Project	IEEE 802.16 Broadband Wireless Access Working Group < http://ieee802.org/16 >	
Title	Consolidation of Coexistence Control Channel	
Date Submitted	2007-07-09	
Source(s)	Mariana Goldhamer Alvarion Tel Aviv, 21 HaBarzel Street Israel	Voice: +972 3 6456241 Fax: +972 3 645 6204 mailto:mariana.goldhamer@alvarion.com
Re:	LE TG Call for Contributions	
Abstract	More details for CXCC	
Purpose	Approval	
Notice	<i>This document does not represent the agreed views of the IEEE 802.16 Working Group or any of its subgroups.</i> It represents only the views of the participants listed in the “Source(s)” field above. It is offered as a basis for discussion. It is not binding on the contributor(s), who reserve(s) the right to add, amend or withdraw material contained herein.	
Release	The contributor grants a free, irrevocable license to the IEEE to incorporate material contained in this contribution, and any modifications thereof, in the creation of an IEEE Standards publication; to copyright in the IEEE’s name any IEEE Standards publication even though it may include portions of this contribution; and at the IEEE’s sole discretion to permit others to reproduce in whole or in part the resultin

Figure h62—Desired spectral densities for different channel BWs

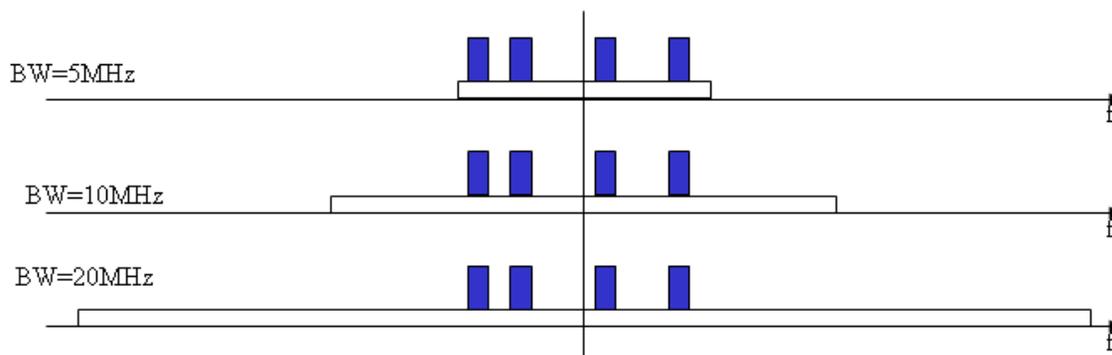
The following figures show the desired spectral density for radio signaling. Independent of the actual channel width, the preambles are sent using the narrowest channel possible in the band. In the following example, in which channels of 5, 10 and 20MHz may be used, the narrowest channel is 5MHz and any other system will be able to detect the preambles, which are not attenuated by any radio filter. The narrowest channel will be centered in the frequency domain around the actually used channel center.
